Value Engineering Study Final Report

Malabar Road (SR 514) PD&E Study
From East of Babcock Street (SR 507) to US 1
Brevard County, Florida

State Road 514 (Malabar Road) from Babcock Street to US 1 PD&E Study

Study Dates: August 18 – 22, 2014

RECOMMENDATION No. 1: Maintain the existing two-lane typical section between Corey Road and the railroad tracks

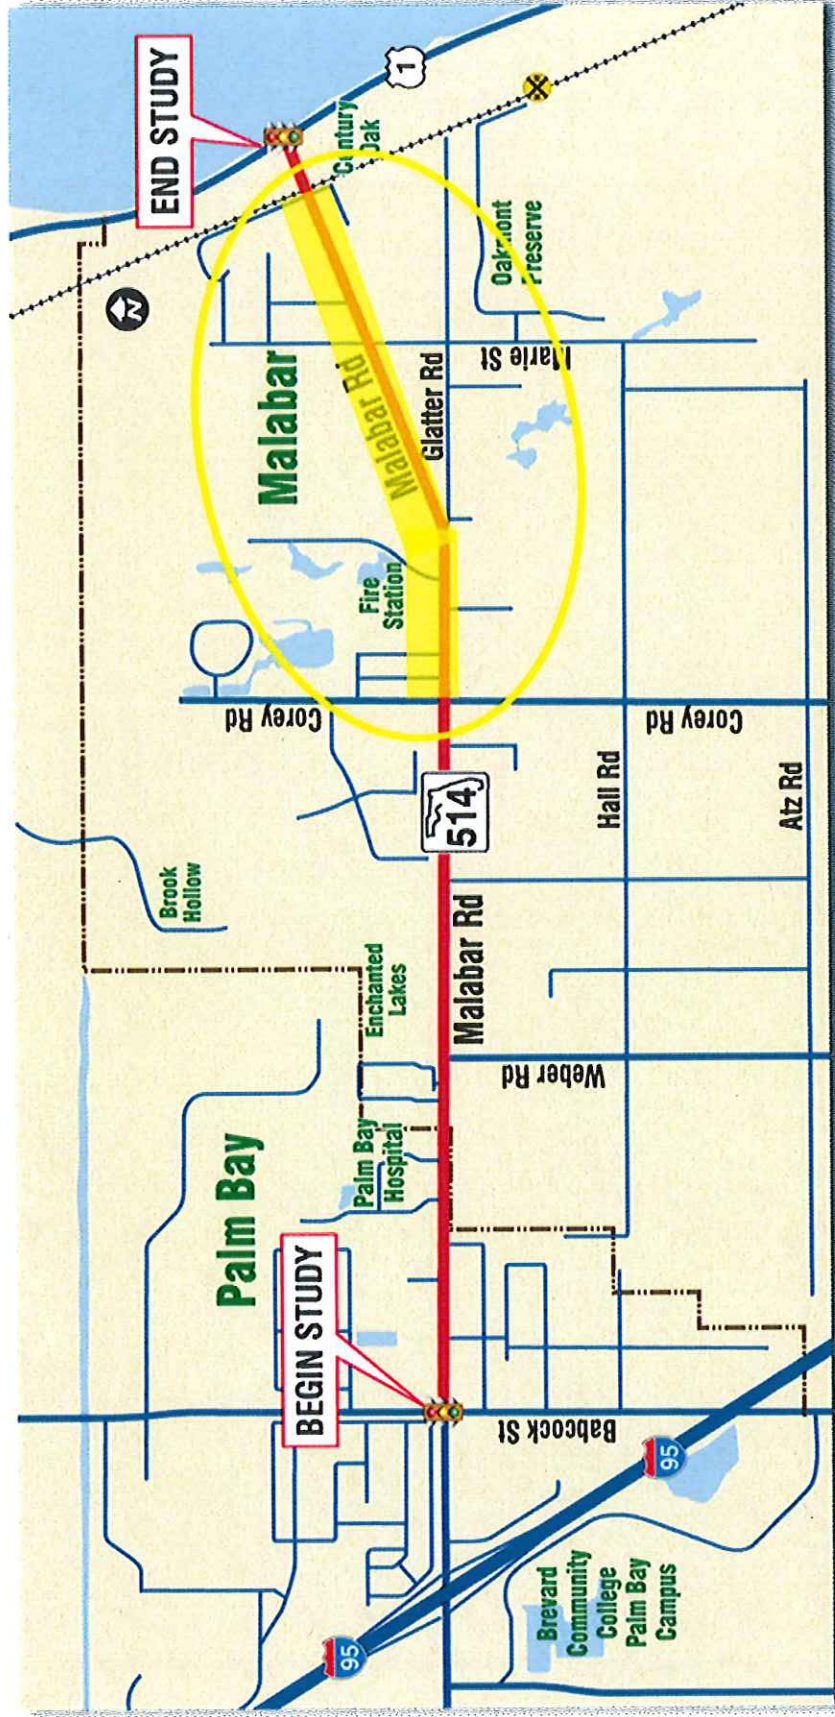
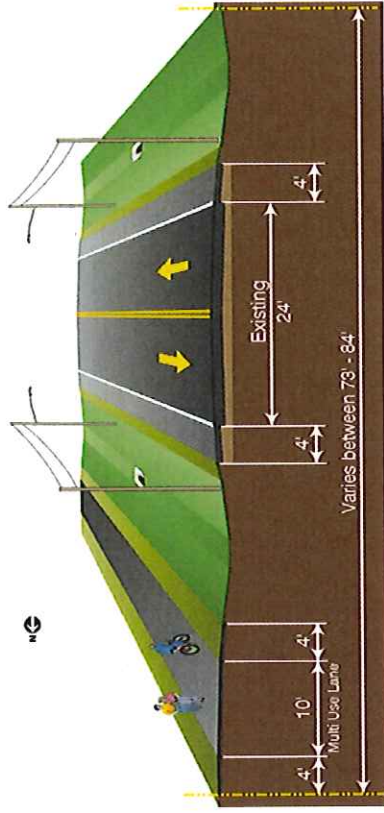
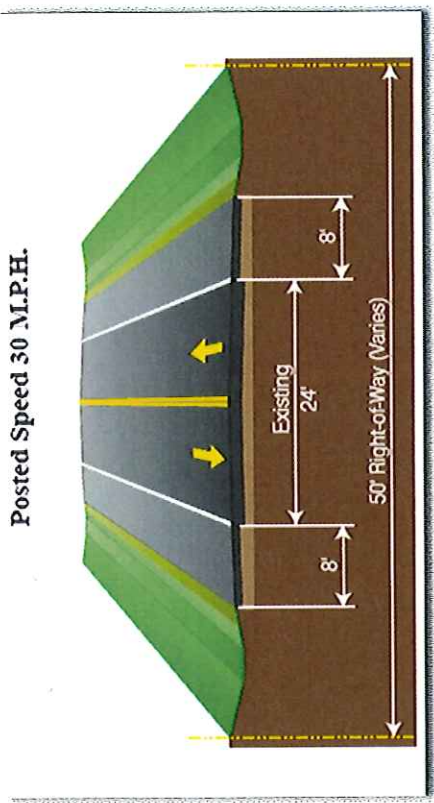
The PD&E Documents show the proposed roadway between Corey Road and US 1 mainly as a reconstruction/widening of existing two lanes to a 3-lane typical section with a bi-directional turning center lane. There is a transition from a 4-lane suburban typical section to existing 2-lane roadway that begins west of Corey Road and it ends approximately 1,500 feet east of Corey Road. The existing 2-lane roadway is utilized for approximately 3,000 feet. A proposed 3-lane typical section begins 300 feet west of Marie Street and ends at US 1.

This alternative would taper down from the proposed 4-lane rural typical section to the existing 2-lane rural typical section (no-build) until the railroad crossing at station 284+00.00. The Malabar Trail will be added within the “no-build” portion of the project from Corey Road to Marie Street. Eastbound beyond the railroad to US 1, the typical would follow the recommendations of the PD&E documents of a 3-lane urban typical with 4-ft. bike lanes and 6-ft sidewalks.

- The level of service could be reduced at peak travel times
- There may be a perception of no change for the east end residents
- There will be no pedestrian facilities east of Marie Street to accommodate the future multi-modal transportation

This recommendation would leave a large portion of Malabar Road, between Marie Street and US 1, without multi modal accommodations. It is an initiative of the Florida Department of Transportation to provide multimodal accommodations on all state roads. The existing typical section does not accommodate pedestrians/bicycles. Additionally, the PD&E recommended a three lane typical section, which would provide additional traffic capacity in the downtown section of Malabar and opportunities for pedestrian refuges.

RECOMMENDATION No. 5: Transition from 4-lane to a 2-lane existing west of Corey Road to avoid the Fern Creek Crossing Park and the Post Office

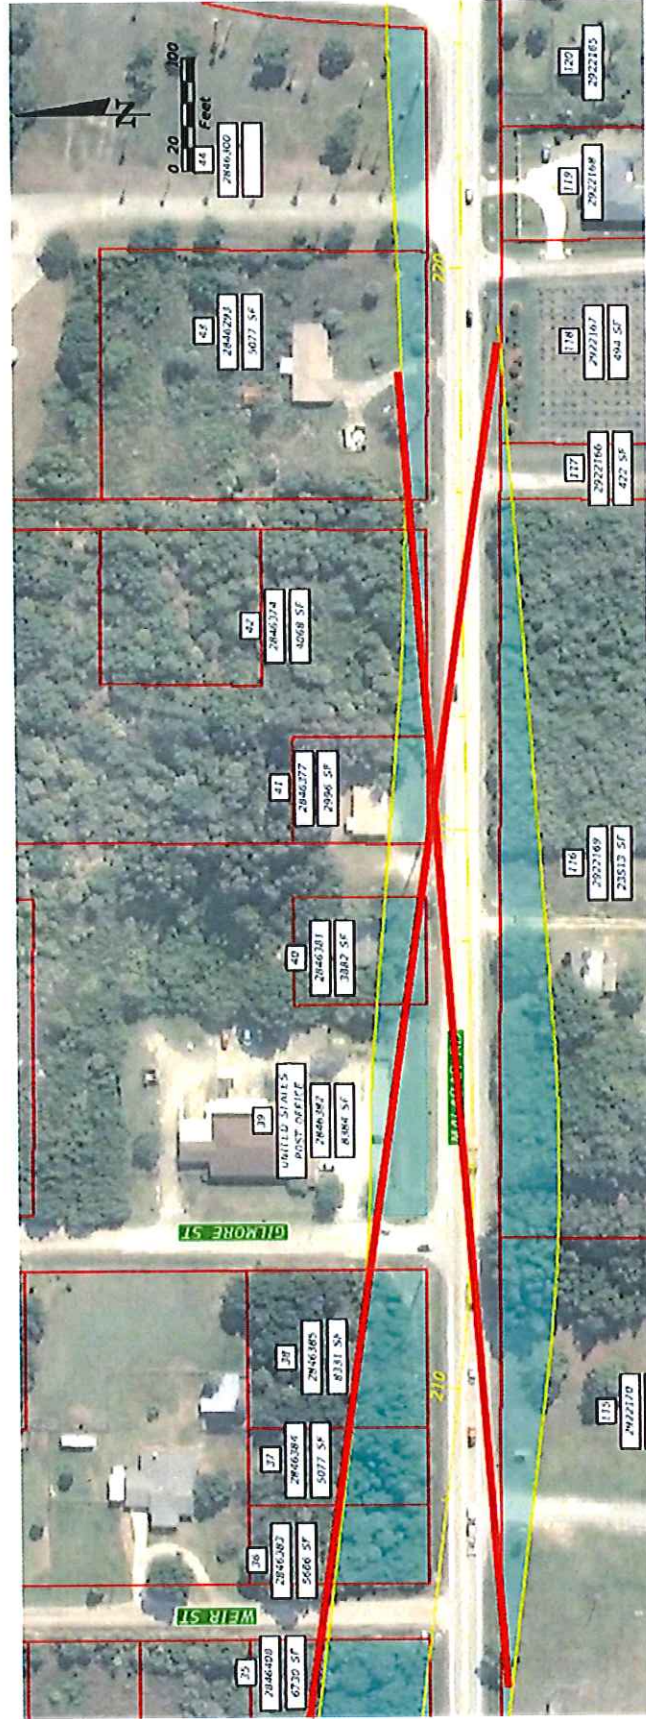
The PD&E Documents show a transition on the east side of Corey Rd. from a 4-lane to a 2-lane roadway. The transition is made to avoid the Section 4(f) Fern Creek Crossing Park in the southwest quadrant of the intersection of SR 514 and Corey Road.

As in Recommendation #1, this recommendation also does not account for multimodal accommodations in downtown Malabar and necessary turn lanes at Malabar Road (SR 514) and US 1. See Response for Recommendation #1.

RECOMMENDATION No. 6: Maintain the existing two-lane typical section between Corey Road and US 1

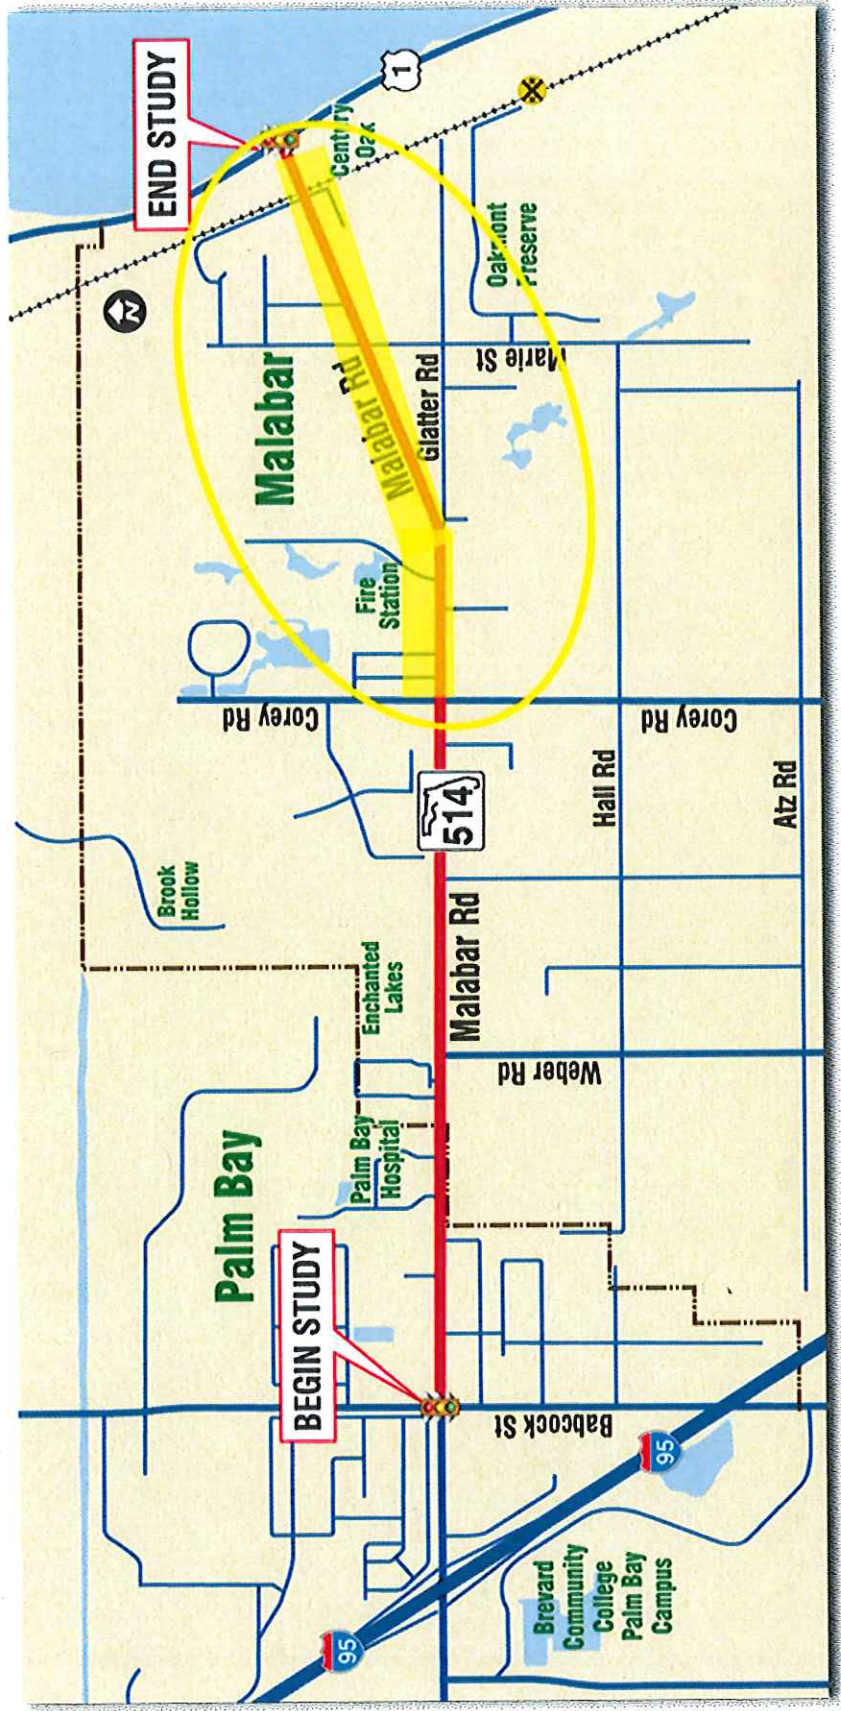
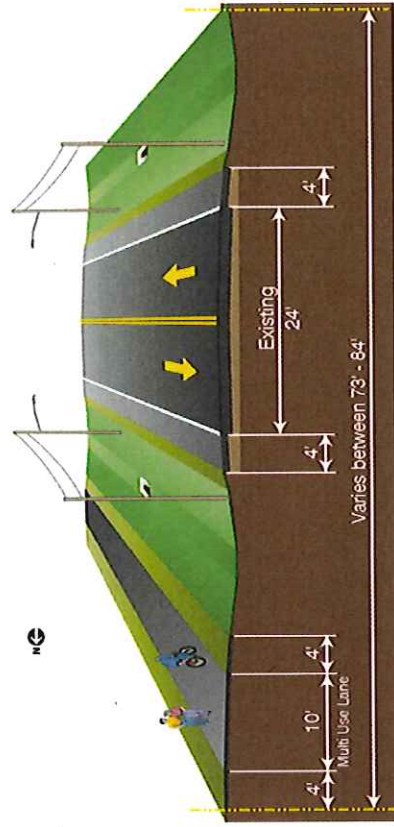
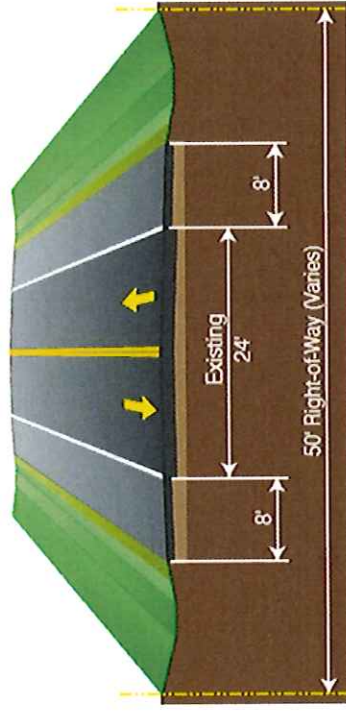
The PD&E Documents show the proposed roadway between Corey Road and US 1 mainly as a reconstruction/widening of existing two lanes to a 3-lane typical section with a bi-directional turning center lane. There is a transition from a 4-lane suburban typical section to existing 2-lane roadway that begins west of Corey Road and it ends approximately 1,500 feet east of Corey Road. The existing 2-lane roadway is utilized for approximately 3,000 feet. A proposed 3-lane typical section begins 300 feet west of Marie Street and ends at US 1.

- Decreased Level Of Service
- There may be a perception of no change for the east end residents
- There will be no pedestrian facilities east of Marie Street to accommodate the future multi-modal transportation

See response for Recommendation #1. The PD&E team recommends not accepting.

RECOMMENDATION No. 7: Maintain the existing two-lane typical section between Corey Road and US 1 but make turning lane improvements at the intersection at US 1

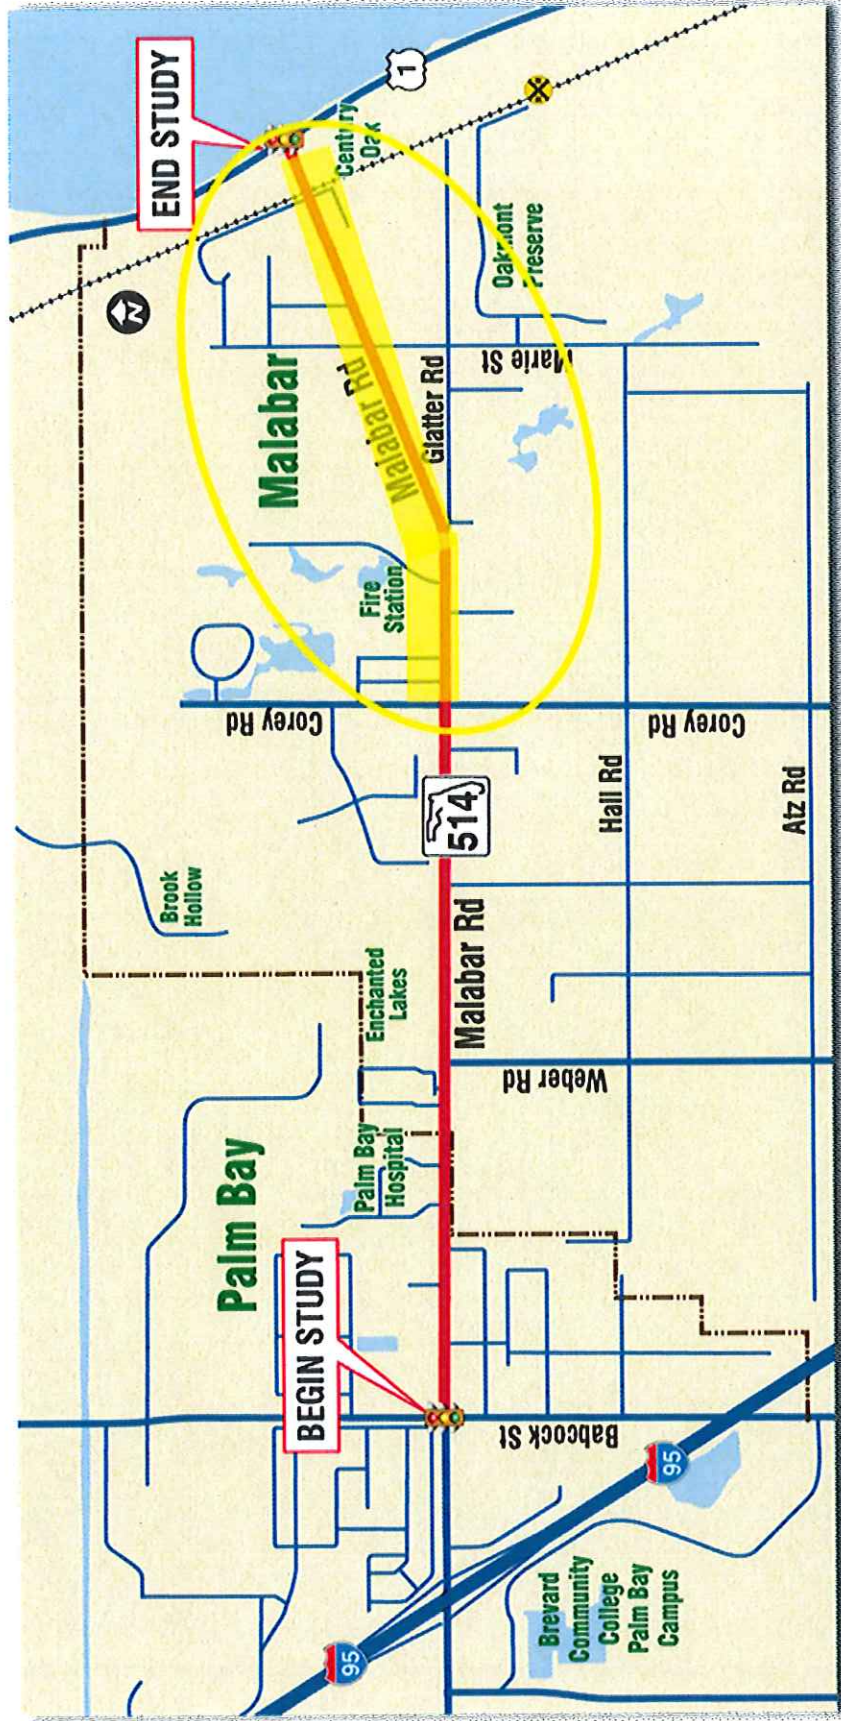
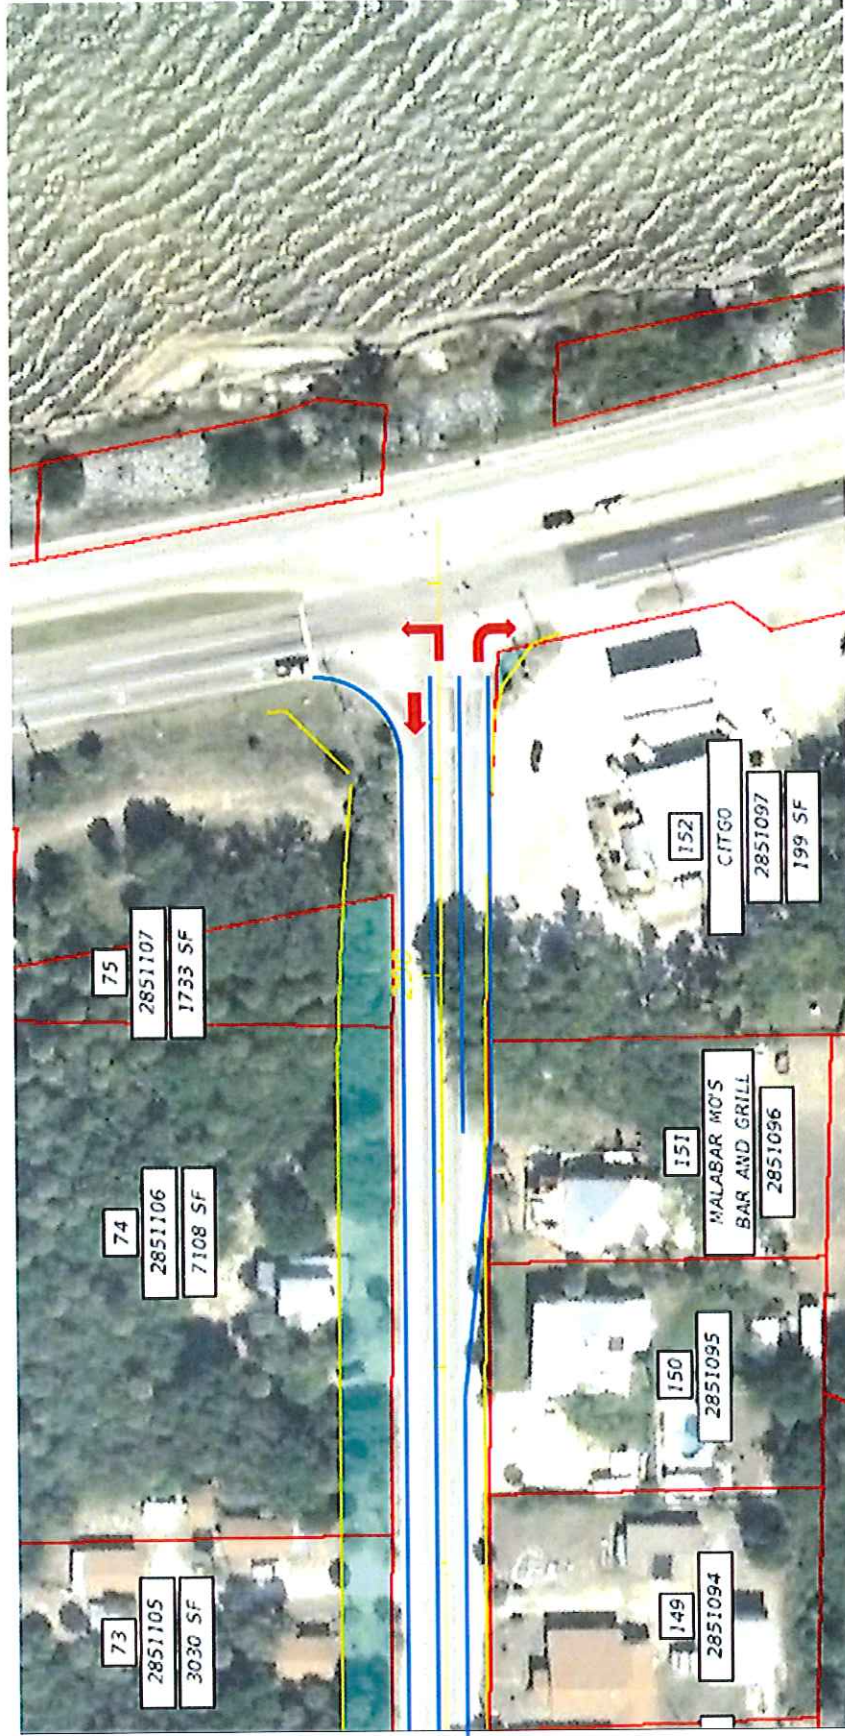
The PD&E Documents show construction of a 4-lane suburban typical section transitioning to the existing 2-lane rural section from east of Corey Road to Shiflett Lane. A 10-foot multi-use path will be constructed on the north side of the roadway from east of Corey Road and continue east to Marie Street where it will be connected to the future Malabar Trailway. A 3-lane urban typical section will be constructed from east of Marie Street to US 1.

- Would not improve access to businesses and residences along Malabar Road from east of Marie Street to US 1.
- Would not provide for multi-modal transportation that would facilitate the future construction of the Malabar Trailway.

See response for Recommendation #1. Although this recommendation provides the necessary turn lanes at the intersection of Malabar Road (SR 514) and US 1, it does not provide multimodal accommodations.
